DRAWING TITLE
Existing & Proposed Level Plan Sheet 2/4

PROJECT
**Phase 2
Bicester Eco Village
Bicester
Oxon**

JOB NUMBER 15-1859	DRAWING NUMBER 02-2	REVISION P01
-----------------------	------------------------	-----------------

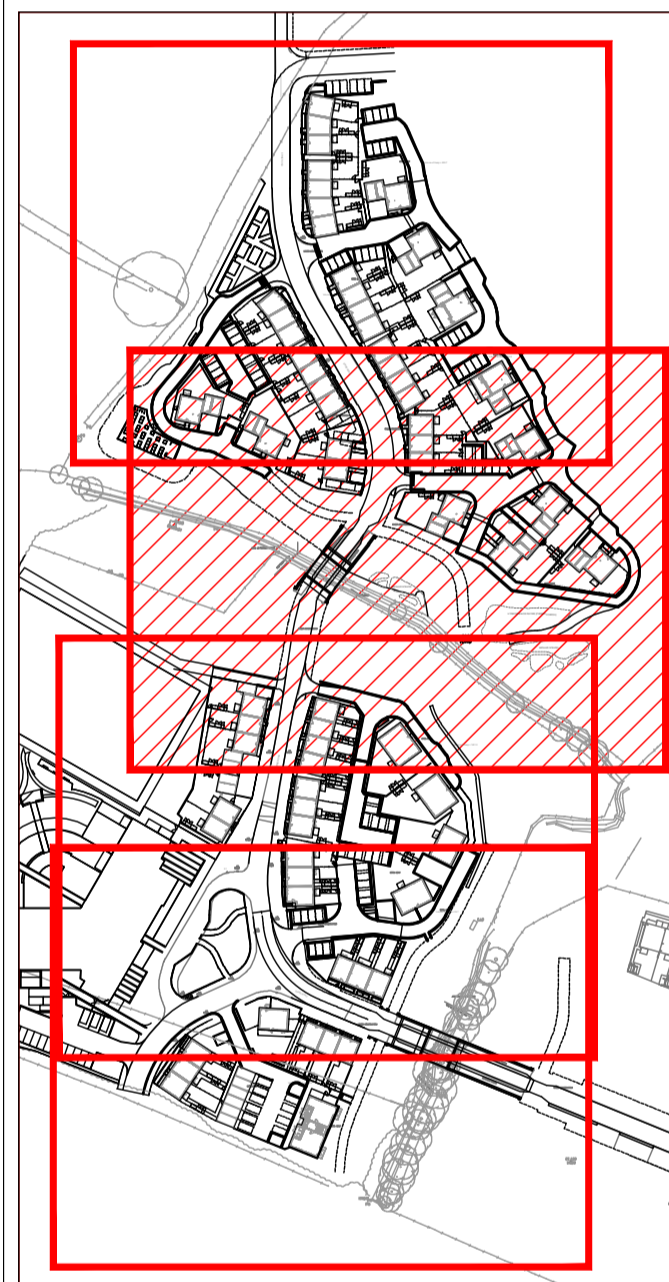
Note
Banking shown but this does conflict with Hyder Ecological scrapes within river corridor. Hyder to confirm relocation of scrapes.
